Access Compliance Report Public Rights-of-Way (Curb Ramps)

Main Street: MARTHA_ANN_DR Cross Street: COLERIDGE_DR Location: E

ADA ID: RPAT211202132324 Ramp Type: Type 1 - Perpendicular Diagonal Initial Pass/Fail: Pass Overall Compliance: No Severity Score: 5

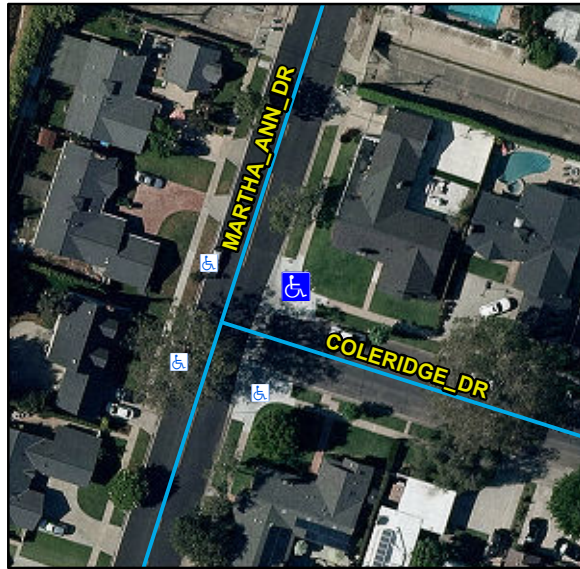
N/A	Ramp Inside Crosswalk 1	N/A	Yes	Ramp Inside Crosswalk 2	N/A
	Crossing 1 Slope (%)	7.1		Crossing 2 Slope (%)	2.6
	Crossing 1 Cross Slope (%)	0.8		Crossing 2 Cross Slope (%)	1.3
Yes	Gutter Ponding	No	Yes	Curb Slope	2.8
Yes	Gutter Lip Height (in)	0		Road Run Slope (%)	2
No	Gutter Run Slope (%)	8.3		Road Cross Slope (%)	3.2
Yes	Gutter Cross Slope (%)	1.2			
Yes	Overall Surface Condition: Acceptable		Yes	Perp Joint Present	Yes
	Cross Gutter Present?	Yes		Spandrel Present?	Yes
	Replace Cross Gutter?	No		Replace Spandrel?	No

Remove & Replace Gutter.

R304.5.4, STD 1115
